**CITY OF SAN ANGELO  
BELL STREET PAVING, WATER AND WASTEWATER IMPROVEMENTS ALL PHASES  
SAN16188**

**ADDENDUM NO. 1**

**December 21, 2017**

**00 91 13      ADDENDUM NUMBER 001**

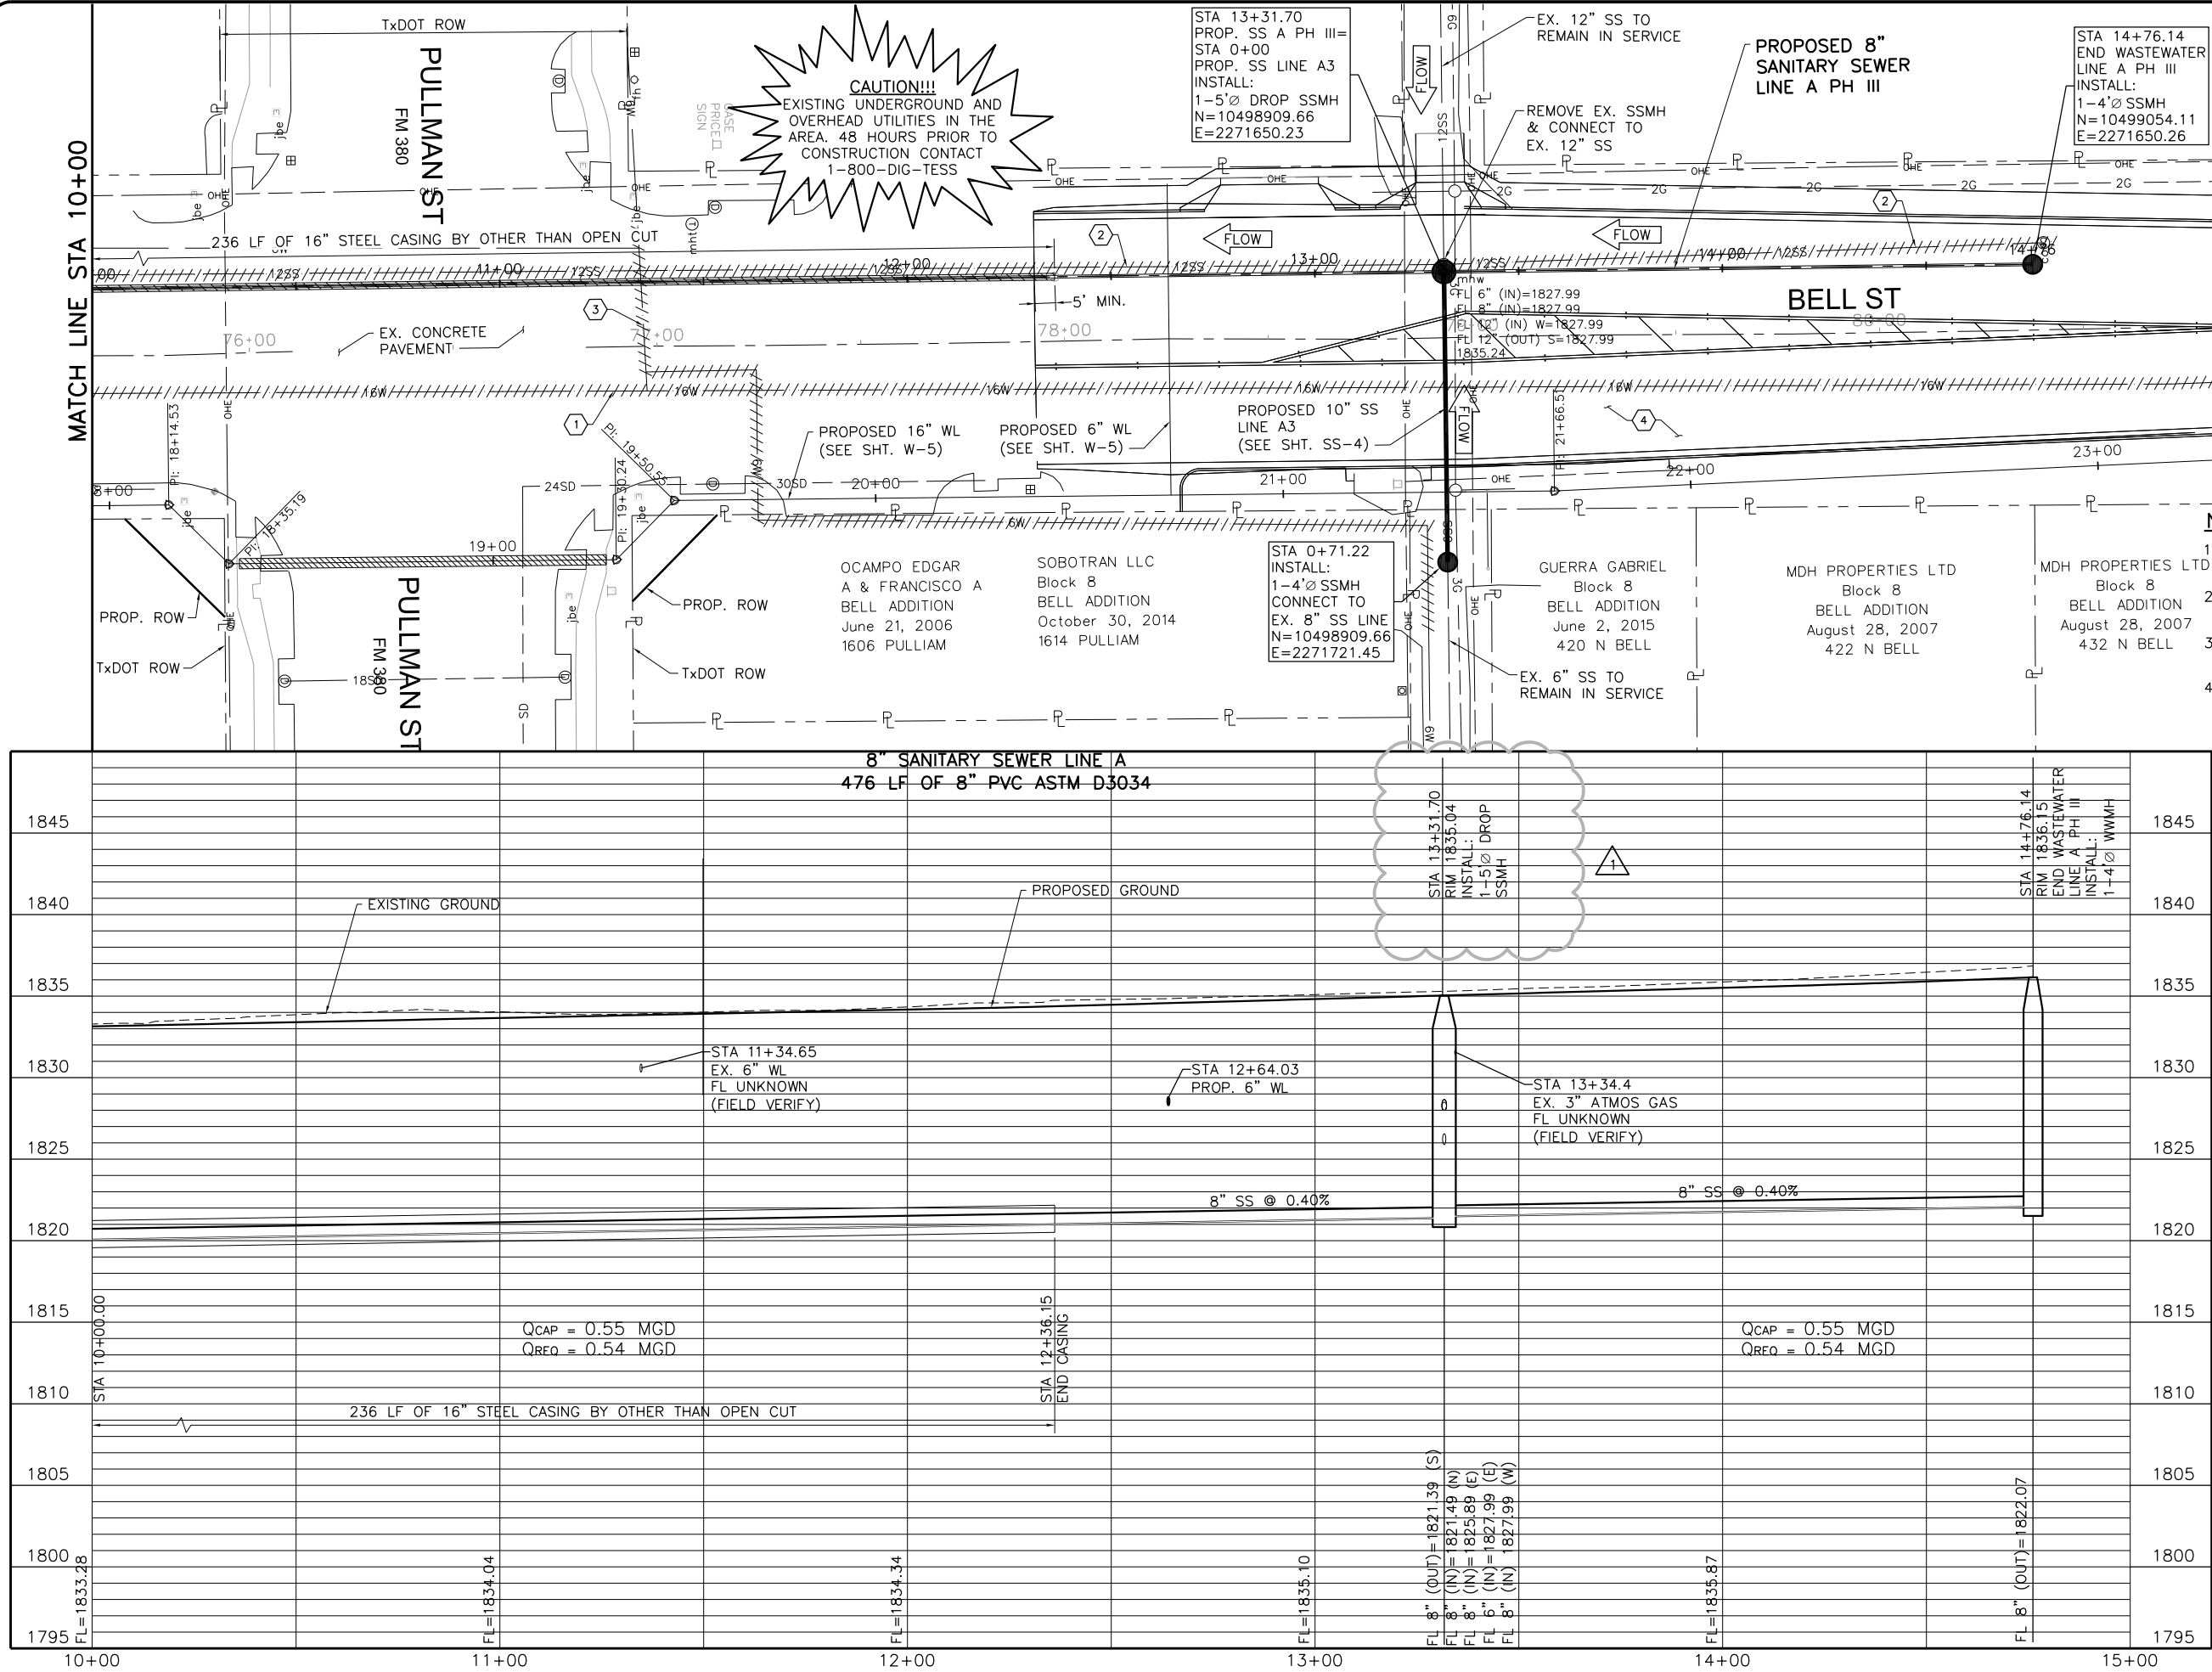
17	Phase III Water Construction;  Plan sheet W 7 sta 32+46.63 Your label shows a 8x6 tee , shouldn’t this be a 16x6 tee?	Yes. FNI will update the drawing.	Refer to Addendum 01, Updated Drawings, Phase III Sheet W-7.			
18	Phase III Water Construction;  Bid item for 8 inch valves phase III — calling for three each only found one at Sta. 8+42.05 plan sheet W 2 Can you tell me were the rest of the 8 inch valves are located?	FNI will update the bid item in the Price Proposal to call for one 8" gate valve instead of three.	Refer to Addendum 01, Updated Technical Specifications, Price Proposal.			
19	Phase III- Sewer;  Sheet SS 2 — Sta 0+ 36.45 shows a 5 foot Man-hole . Your profile sheet SS 4 line A2 shows this manhole to be a four foot diameter manhole , can yes clarify what size you need? Also line A 3 shows four foot drop plan sheet SS 3 Sta. 13+31.70 shows a five foot drop manhole?	The manhole on Sheet SS-4 at STA 0+36.45 should be a 5' Diameter Manhole.  The drop on Sheet SS-4 should match what is shown in Sheet SS-3; therefore, it should be a 5' drop not a 4' drop.	Refer to Addendum 01, Updated Drawings, Phase III Sheet SS-4.

SS-3

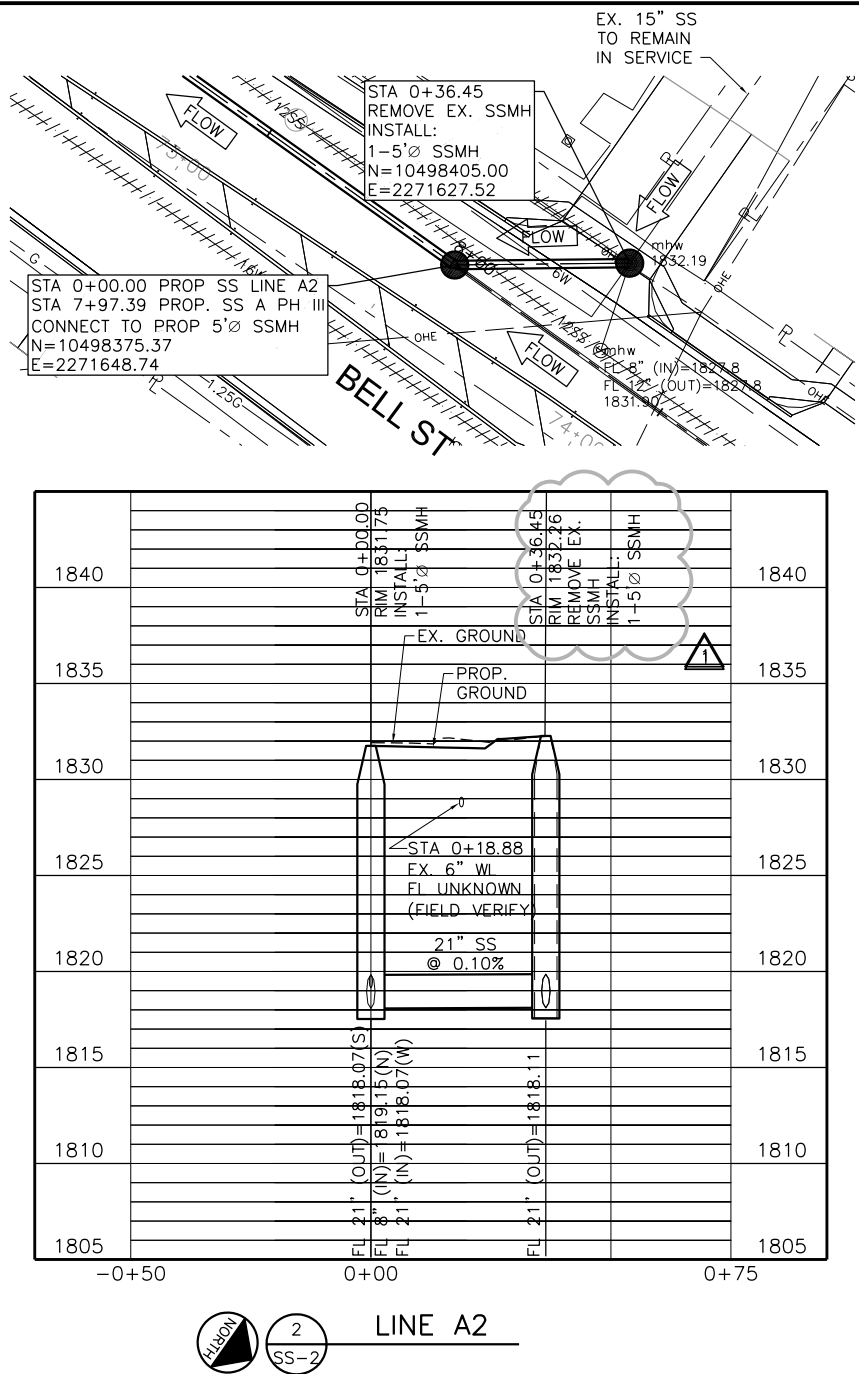
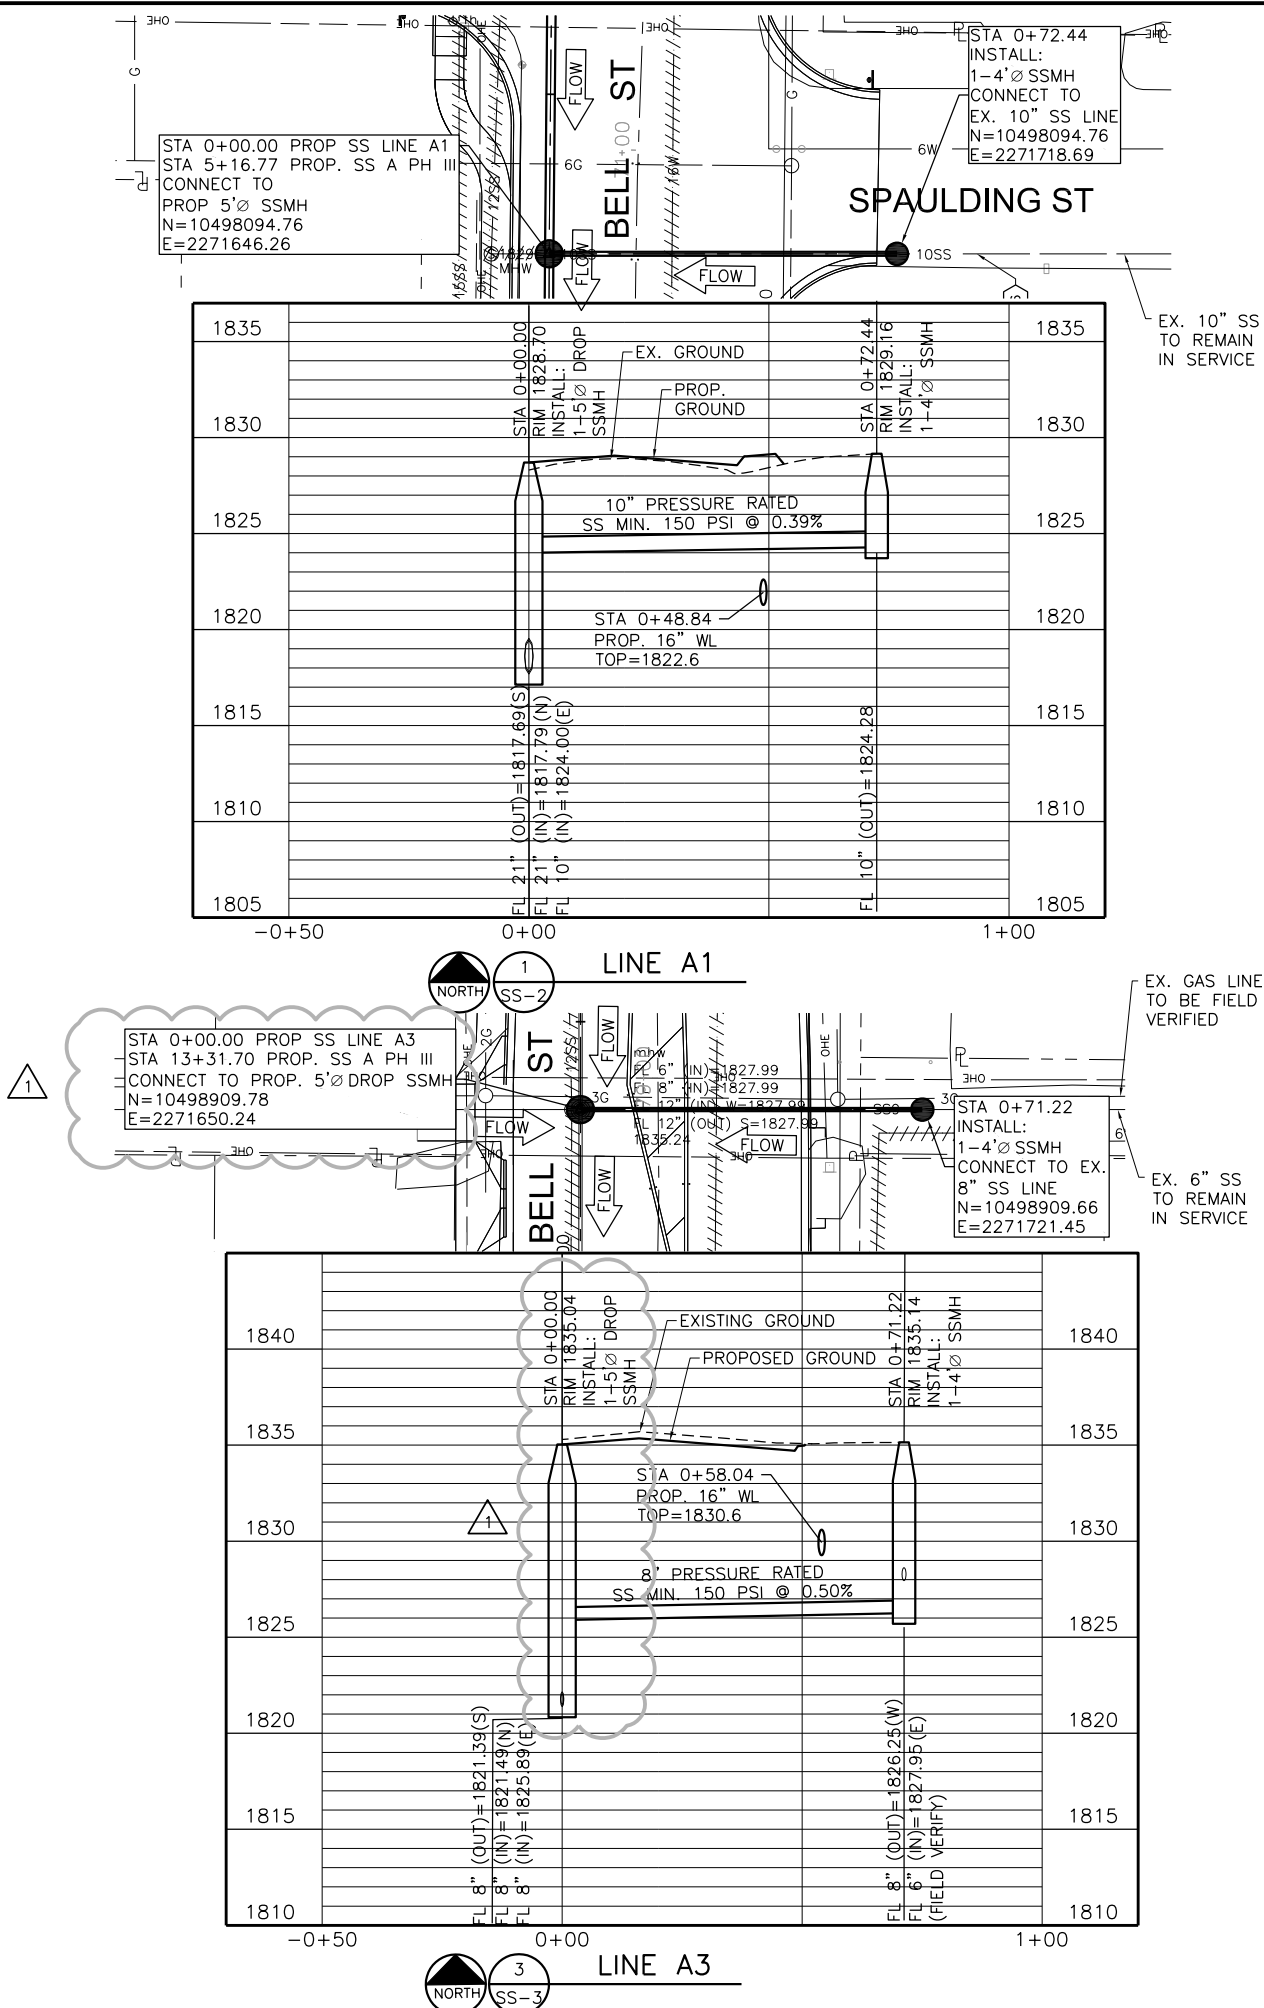
Phase	Replace Sheet	With Sheet
1, 2, 3	NOTES-1	NOTES-1
1,2, 3	NOTES-2	NOTES-2
2	W-1	W-1
2	W-2	W-2
2	W-9	W-9
2	W-10	W-10
2	W-15	W-15
2	W-16	W-16
3	W-5	W-5
3	W-7	W-7
3	SS-3	SS-3
3	SS-4	SS-4
